ARM1022E Rev0 Errata List

Document number: ARM1022E -PRDC-000705 12.0
Date of Issue: 24th June 2002
Author: Paul Garden
Authorised by: John Cornish

This document describes the known errata in the all ARM1022E revisions.

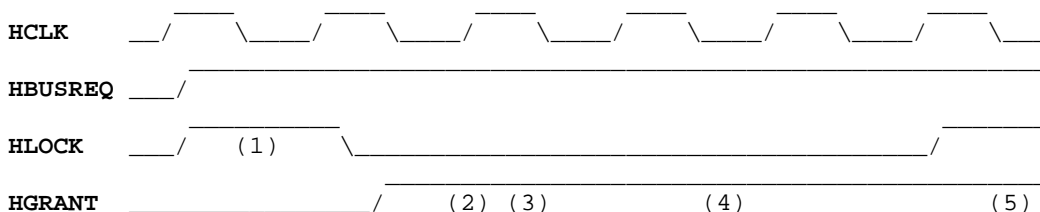
The HLOCK signal may assert for a single cycle near SWPs under very specific circumstances.

The following waveform shows the AHB signals to/from the arbiter. It is worth noting, that the compliance problem is solely related to the communication between the ARM1022E and the AHB arbiter. None of the address/control or data signals are involved.

- (1) HLOCK is erroneously asserted along with HBUSREQ for one HCLK cycle due to the pending swap instruction.
- (2) The AHB verifier complains, that HLOCK is removed before being granted via HGRANT!!!
- (3) The first store out of the Write-buffer takes place.
- (4) The second store out of the Write-buffer takes place.
- (5) The swap takes place as one locked (atomic) transfer.

None required.
